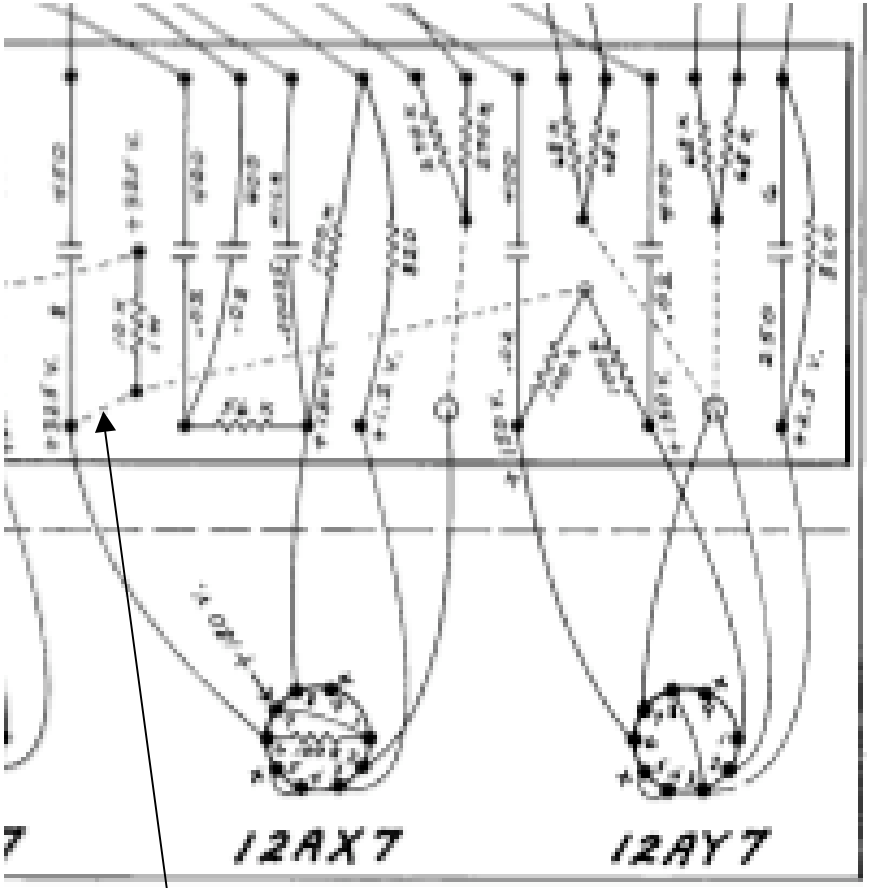
Did you use the Fender Bassman layout for your JTM45? Could be you missed this wire? (Hence I suggested checking DC continuity with your R-meter.
